**SR-2 – ADVISORY STAFF REPORT (05-08-2026)**

**ADDRESS:** 15091 PENROD

**APPLICATION NUMBER:** HDC2026-00035

*Front of house, east side, Side A by the applicant's bid sheet.*

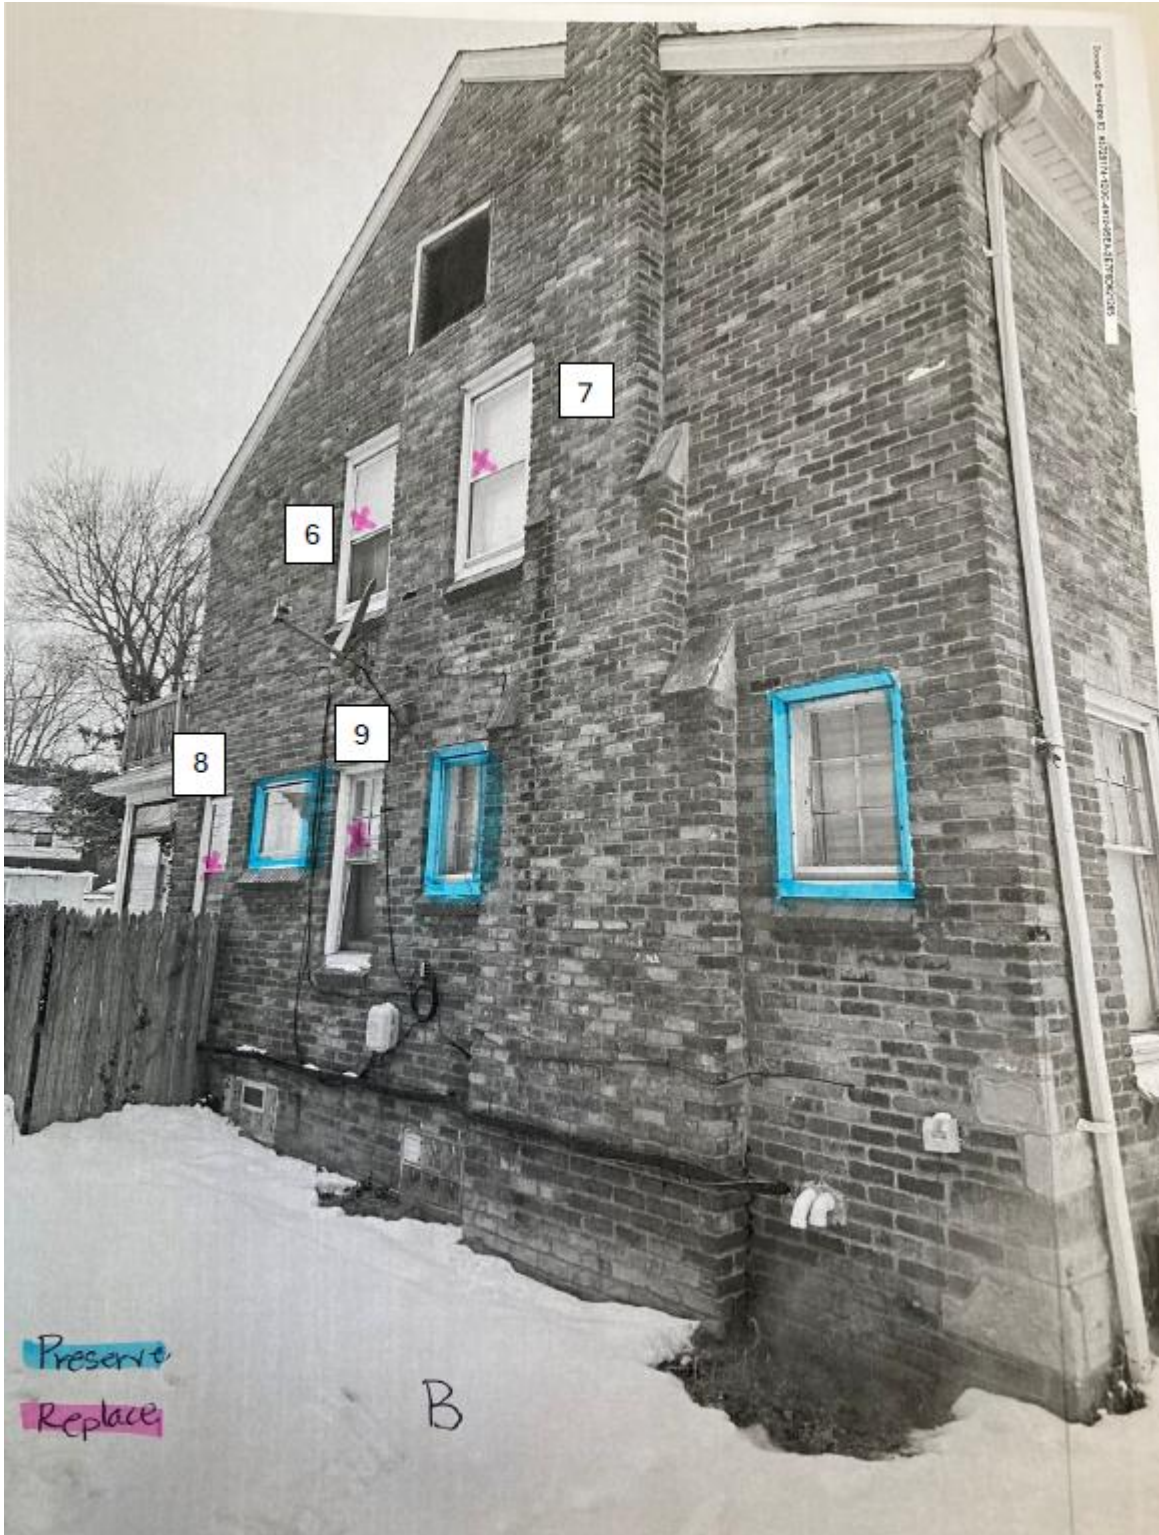
- It is staff’s opinion that the 10 windows with divided lights in the upper sashes that are proposed for replacement are historic, character-defining features of the house. Five of these historic windows are on the primary façade, including two cottage-style windows (the upper sashes are shorter than the lower sashes). It is staff’s opinion that the five windows without muntins proposed for replacement may be of historic age, but staff does not find them to be character-defining. Windows 6, 7, 10, and 12 (south side and rear) have proportions that would be typical of other (historic) windows but lack muntins; as a result, it is staff’s opinion that these windows are likely replacements. Window 16 is a kitchen window over a sink, and its proportions look wider and shorter than the typical taller-than-wide historic windows elsewhere on the house. As a result, staff believes this window opening was modified and staff believes this to be a replacement window as well.

South side of house, Side B on the applicant's bid sheet.

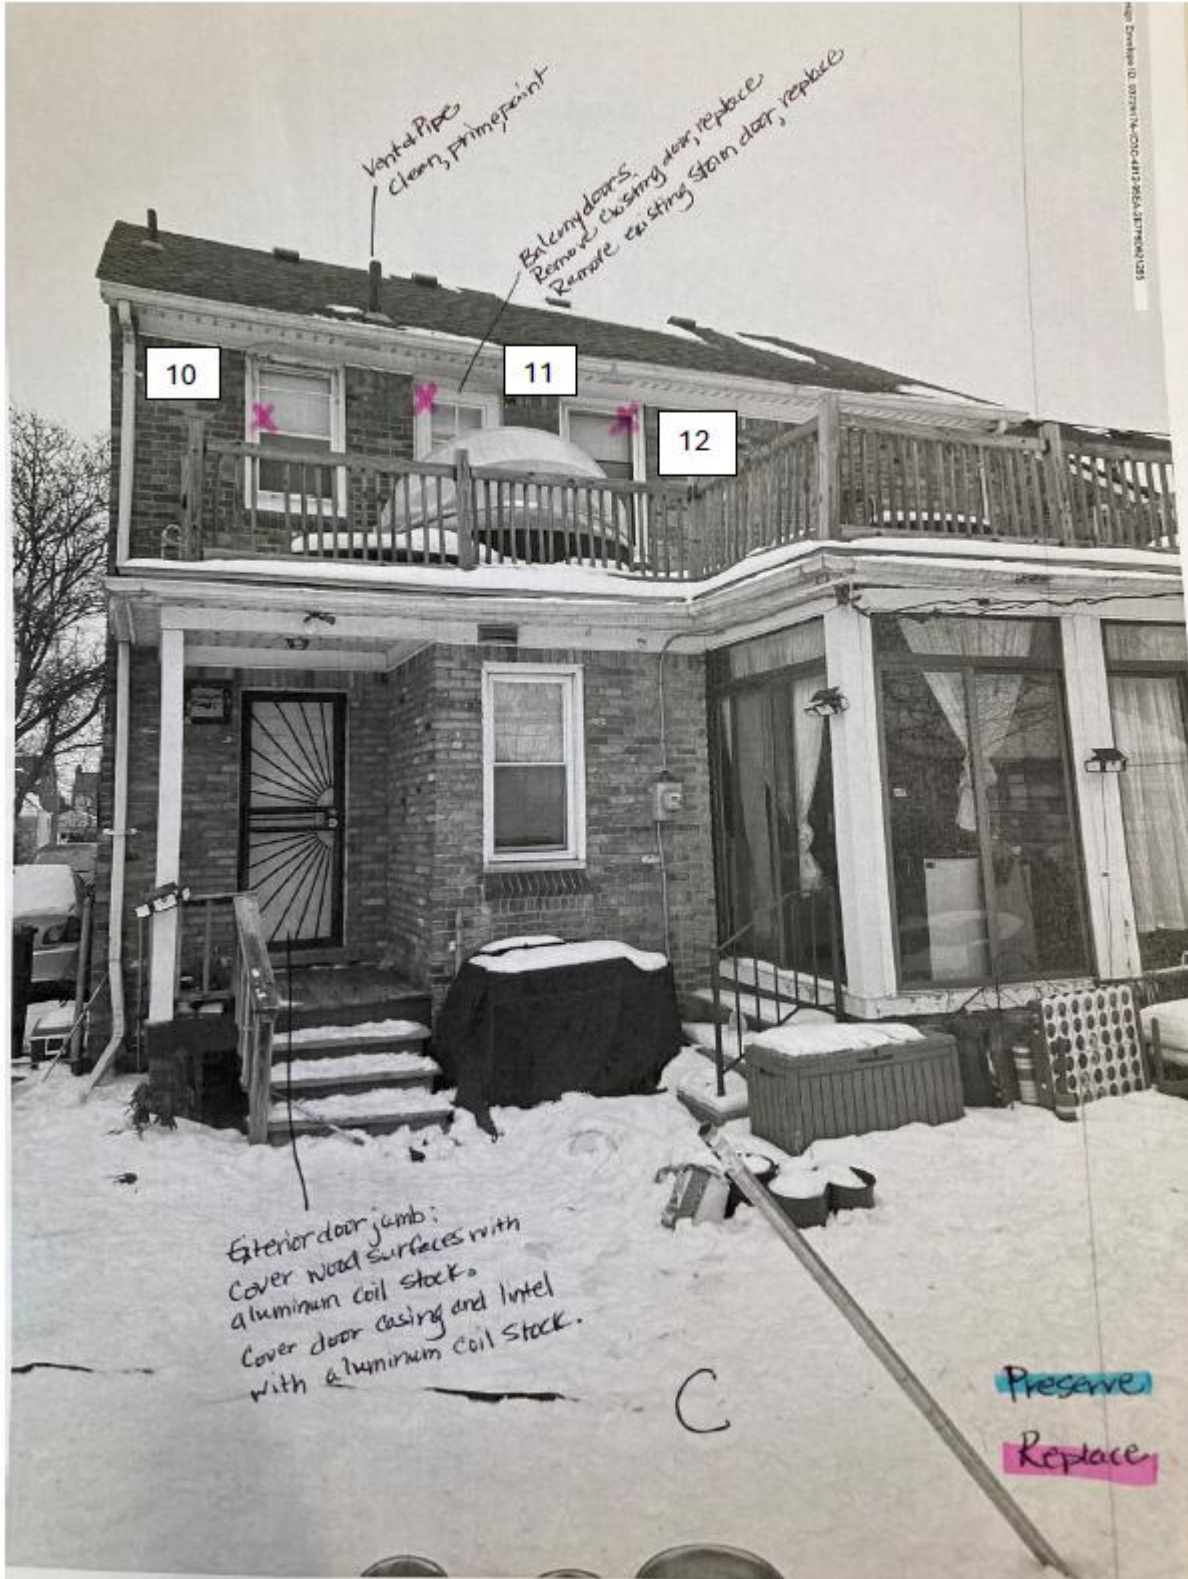
- Of the 15 windows proposed for replacement, 10 are wood with muntins and divided lights in the upper sashes. They all have storm windows installed.
- The other 5 windows to be replaced lack muntins. These windows are Windows 6, 7 (both on Side B), 10, 12, (both on the rear/ Side C), and 16 (on Side D). Staff is not able to discern these windows’ materials with certainty, but several appear to be wood. All 5 of these windows also have storm windows installed.

- By this guidance, for the five non-historic windows, staff finds the proposed replacement windows (wood, aluminum-clad, one-over-one windows without simulated divided lights) compatible with the historic appearance and character of the building. They fill the openings and operate as a wood double-hung would, but replicating the missing window with muntins is not required.

Rear of house/ west side, or Side C on applicant's bid sheet.

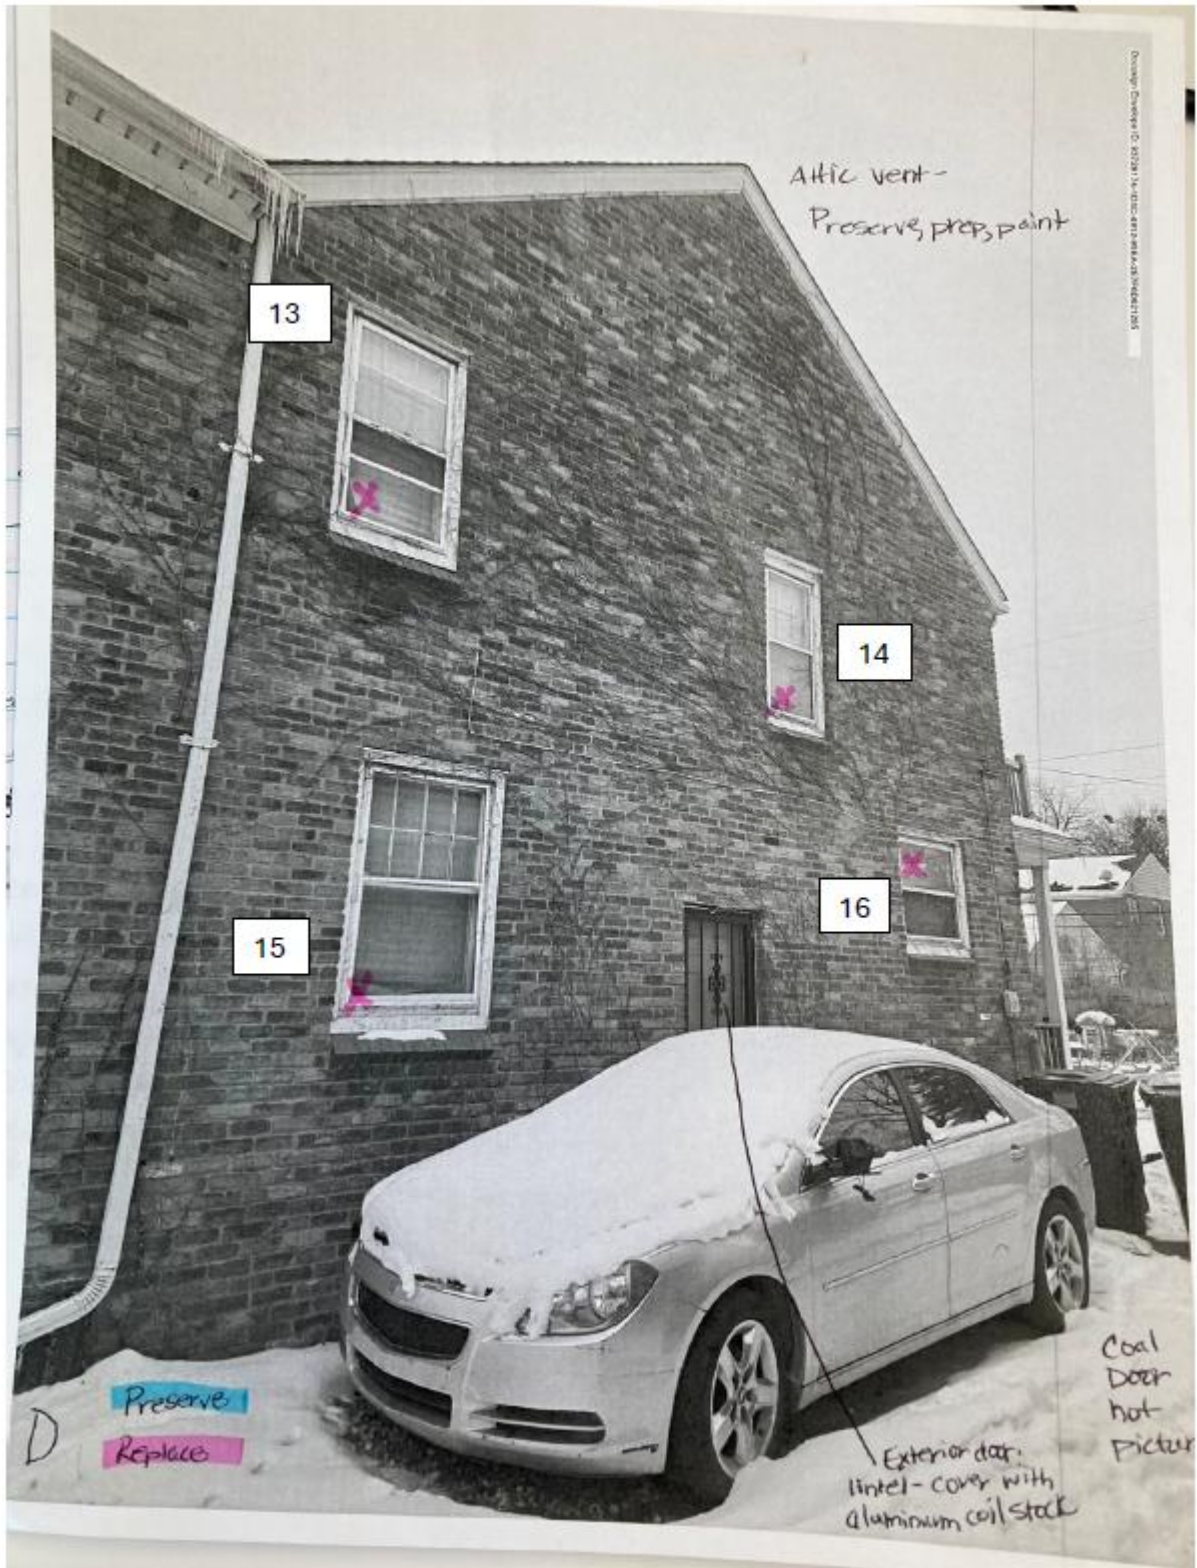
- The doors proposed for replacement are on the rear at the balcony, and both are wood.
- Rosedale Park’s Element of Design 10 (Relationship of architectural details) states: “*The architectural elements and details of each structure generally relate to its style.*” It is staff’s opinion that the wood doors proposed for replacement are historic, character-defining features.

- Staff notes that should the Commission determine that the replacement of the rear balcony doors is appropriate and issues a Certificate of Appropriateness for that scope item, staff would note that the proposed replacement door is not appropriate for this house’s architectural style and an approval should be conditioned upon the applicant submitting an appropriate door to staff for review and approval.
